# **Planning Inspectorate NSIP ref no TR010037**

## **A47 – A11 Thickthorn Junction**

**Submission from Richard Hawker IP ref No 20028387 Date: 20 March 2022**

### **Deadline D10 comments**

TRAFFIC FLOWS

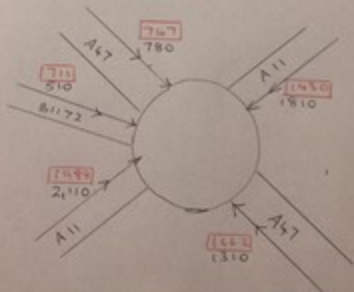
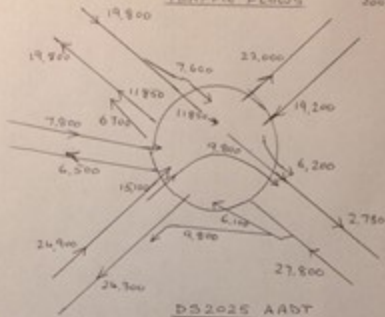
Figures for the dedicated slip lanes linking A47NWbnd to A11SWbnd, and vice versa, in the DS2025 scenario, predict that around 9,800 vehicles of roughly 25,000 will make that turn, i.e. around 35 – 40%. Now considering the BY2015 figures, and taking that percentage of vehicles from those entering the roundabout from the total A47NWbnd show that a total of 660 vehicles could be diverted from the roundabout in the AM peak and 530 in the PM peak. (The same number would be expected to make the turn in the opposite direction). If other sliproads were built from A11SWbnd to A47SEbnd, and A47SEbnd to A11NEbnd, and they took just 15% of the traffic entering the roundabout (a conservative estimate), a total of around **980** vehicles could be diverted from entering the roundabout in the AM peak, (15% of

the total 6538) and **920** in the PM peak (14% of the total 6507). This is thus *more* than the roughly **660** which would be taken by the underpass (based on 2015 figures).

Thus dedicated sliproads could likely achieve a better result than an underpass.
